REMARKS

MARKED UP VERSION OF THE AMENDED CLAIMS

"MARKED UP" VERSION OF SUBSTITUTE SPECIFICATION

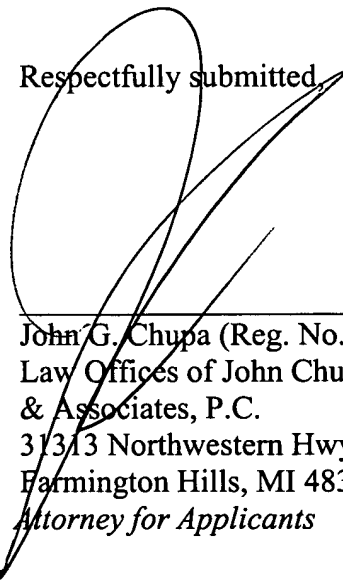
Furthermore, the Examiner has objected to the drawings because none of the Figures show a tripod assembly with an inner race AND a snap ring. Please find the enclosed proposed amendment to the drawings which shows a tripod assembly with an inner race and a snap ring. The Examiner further asserts that the drawings under 37 CFR 1.83(a) must be shown fully assembled. It is respectfully asserted that 37 CFR 1.83(a) does not require an "assembled view" of the invention and that the drawings as amended would enable one skilled in the art to make the invention disclosed in the pending Application.
